Access Compliance Report

Public Rights-of-Way

Intersection ID: 17696	Main Street: DENON_HILLS_DR	Cross Street: E W T HARRIS BV	Location: NW
ADA ID: 6AEF80269FCB	Ramp Type: PerpDiag	Initial Pass/Fail: Fail	Overall Compliance: No
		Severity Score: 10

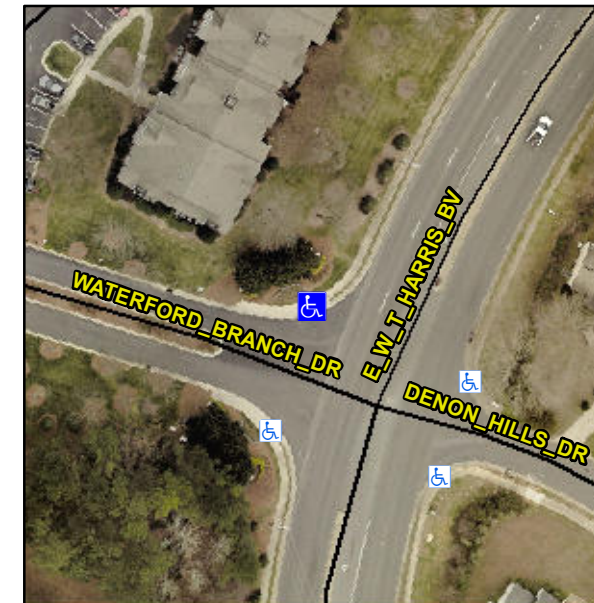
Not Found, R304.5.1, R304.5.3

Compliance	Description	Data	Compliance	Description	Data
N/A	Ramp Length (in)	26.5	Yes	Ramp Slope (%)	8.0
No	Ramp Width (in)	45.5	No	Ramp XSlope (%)	3.2
N/A	Flare Type LT	N/A	N/A	Flare Type RT	N/A
N/A	Flare Slope LT (%)	N/A	N/A	Flare Slope RT (%)	N/A
N/A	Flare Traversable LT?	N/A	N/A	Flare Traversable RT?	N/A
N/A	Landing Length (in)	N/A	N/A	DWS Provided?	N/A
N/A	Landing Width (in)	N/A	N/A	DWS Contrast?	N/A
N/A	Landing Slope (%)	N/A	N/A	DWS Length (in)	N/A
N/A	Landing X Slope (%)	N/A	N/A	DWS Full Width?	N/A
N/A	Landing Curb? (Y/N)	N/A	N/A	DWS Offset (in)	N/A
N/A	Shared Landing?	N/A			
N/A	Gutter Ponding?	N/A	N/A	Gutter Slope (%)	N/A
N/A	Gutter Lip Ht (in)	N/A	N/A	Gutter X Slope (%)	N/A
N/A	Painted X Walk1?	No	N/A	Painted X Walk2?	No
	X Walk 1 Direction	To SW		X Walk 2 Direction	To SE
N/A	X Walk 1 Width (in)	N/A	N/A	X Walk 2 Width (in)	N/A
	X Walk 1 Slope (%)	1.4		X Walk 2 Slope (%)	4.4
	X Walk 1 X Slope (%)	3.3		X Walk 2 X Slope (%)	1.4

Remove & Replace Curb Ramp With Two New Directional Ramps or Equivalent.
